REGULAR MEETING OF THE PLAN COMMISSION OF THE VILLAGE OF WILLOWBROOK TO BE HELD ON WEDNESDAY, SEPTEMBER 5, 2018 AT 7:00 P.M. AT THE WILLOWBROOK POLICE DEPARTMENT, TRAINING ROOM, 7760 QUINCY STREET, WILLOWBROOK, ILLINOIS

Staff Report to the Plan Commission

Public Hearing Date:	September 5, 2018		
Prepared By:	Natalie Zine, Planning Consultant		
Case Title:	18-06: Holmes Elementary School Addition , 5800 South Holmes Avenue, Clarendon Hills, Illinois 60514		
Petitioner:	Maercker School District 60, 1 South Cass Avenue, Suite 202, Westmont, IL		
Action Requested:	Consideration of a petition for approval of an amendment to an existing special use for variations from Title 9 of the Village Code to allow a two-story addition to the existing Holmes Elementary School building and improvements to the bus drop area and landscaping, in the R-1 Zoning District		
Location:	Northwest corner of 58 th Place and Holmes Avenue, south of Christian Church of Clarendon Hills		
Existing Zoning:	R-1 Single Family Residence District		
Existing Land Use:	Elementary School		
Property Size:	4.13 acres		
Surrounding Land Use:	Use		Zoning
	North	Christian Church of Clarendon Hills	OUTSD

Exhibit 4: Proposed Site Plan

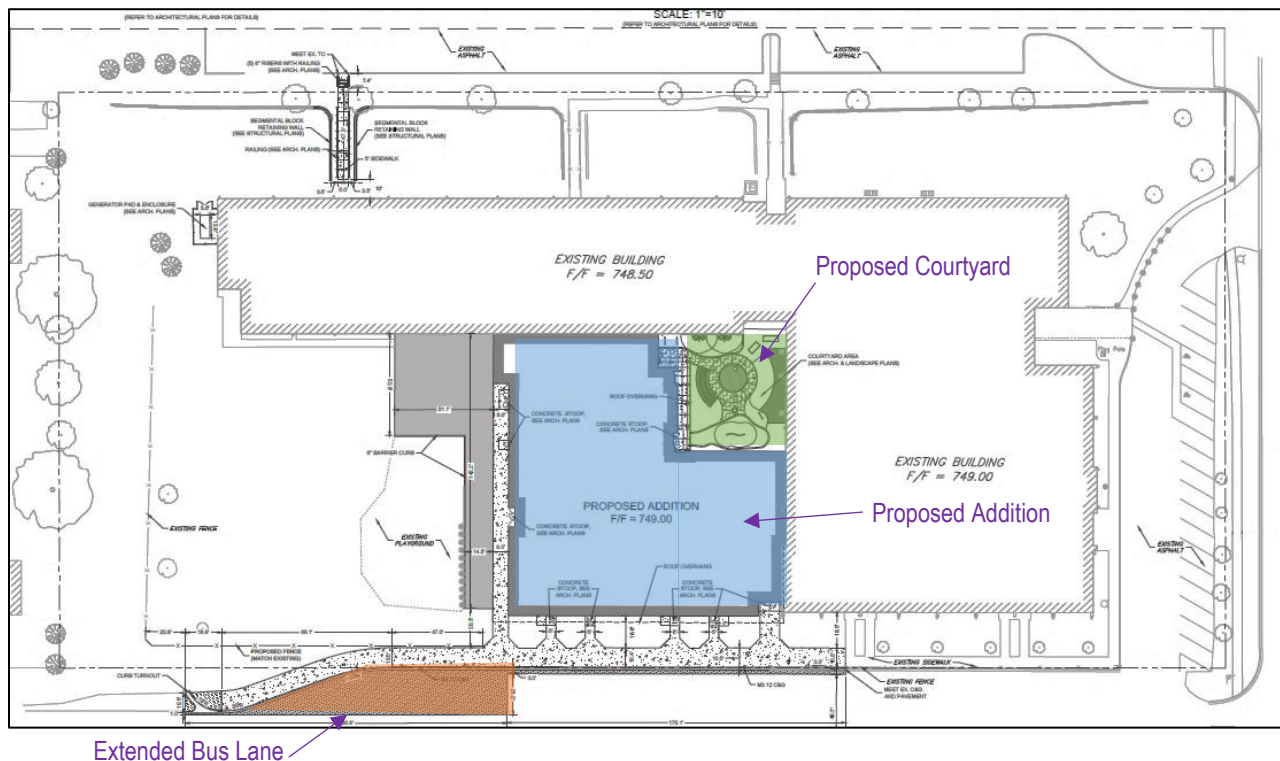
**Applicant has indicated that the proposed setback of 26.8' as indicated on the Site Layout Plan will be modified to comply with the existing variance of 27' pursuant to Ordinance 02-O-06.*

1. Sheet number C1.2 of the engineering plans, "Proposed Improvements for Additions and Remodeling" dated August 7, 2018 shall be revised so that the proposed addition complies with the existing 27' exterior side yard setback.

Project Number:
18024
Issue Date:
AUGUST 7, 2018
Drawn by:
MPS
Sheet Title
EXISTING
CONDITIONS PLAN
Sheet Number

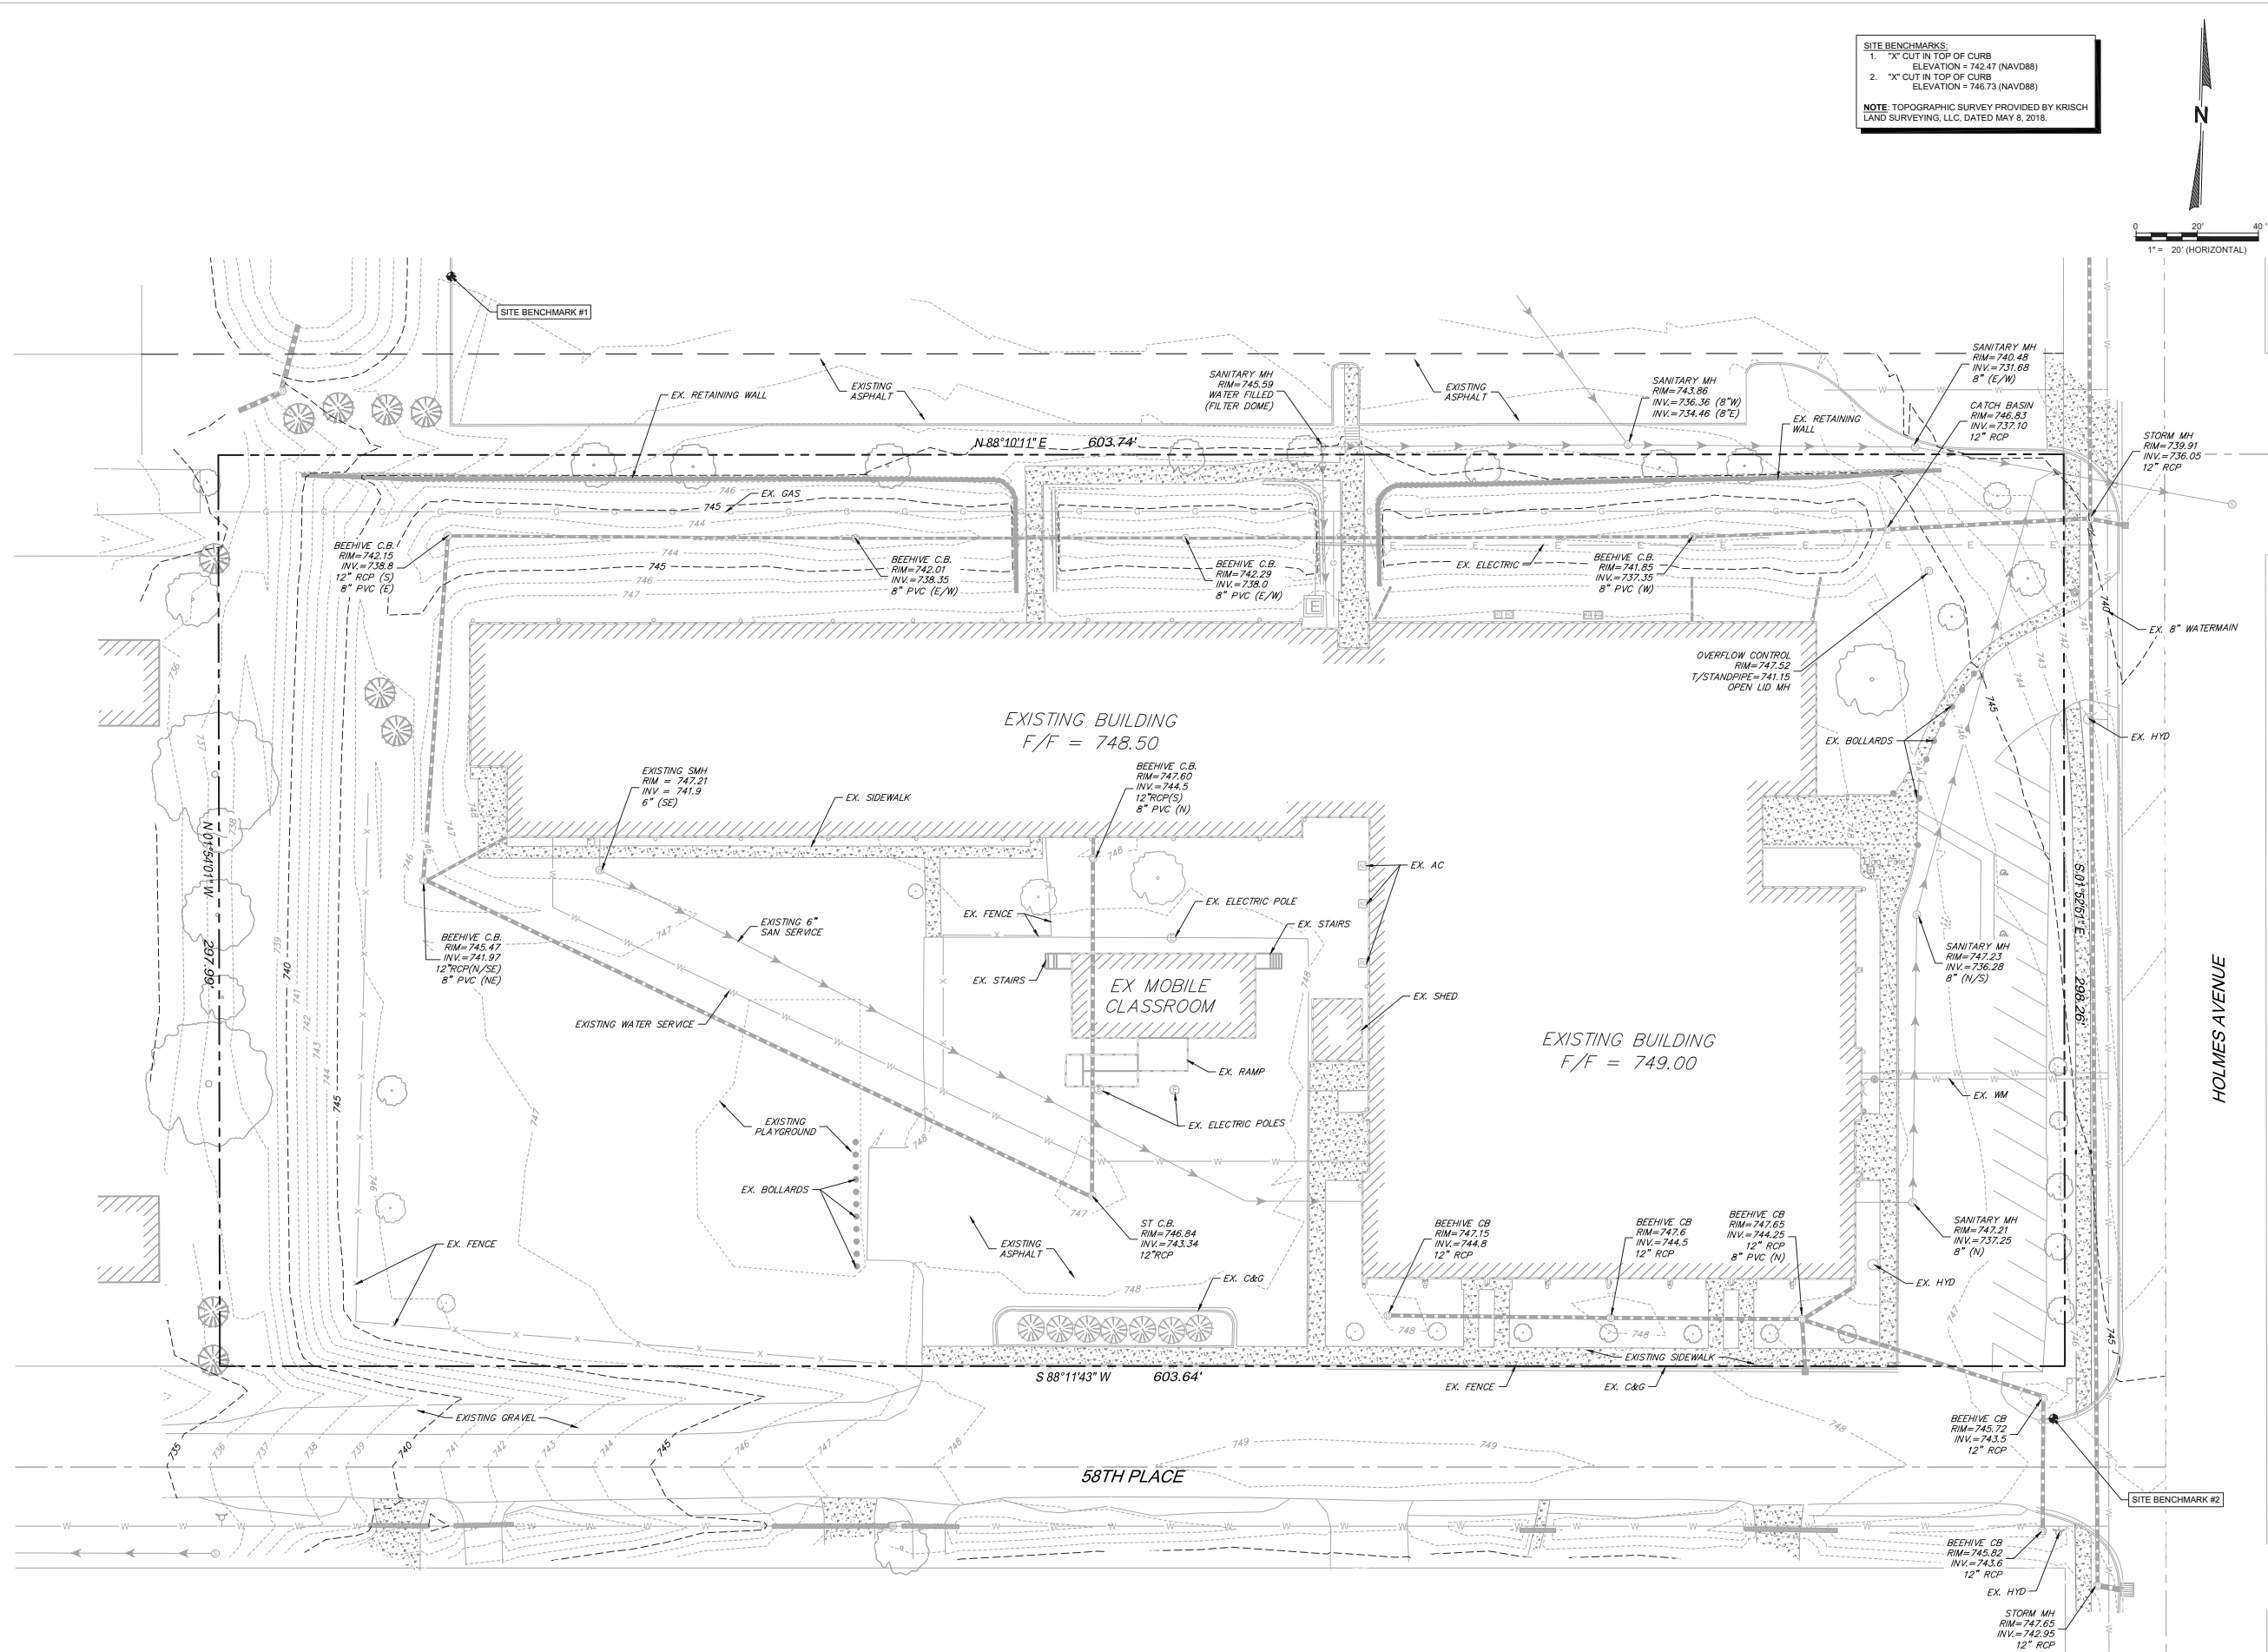
1. On Sheet C1.0 add additional benchmark information to document compliance with Section 15-33 of the County Stormwater Ordinance.
2. On Sheet C2.0 specify the high-water elevation of the detention basins. Also, why are the other two detention areas not being replanted with native vegetation? We believe the ordinance intent is that all detention have native vegetation to meet the BMP requirement.
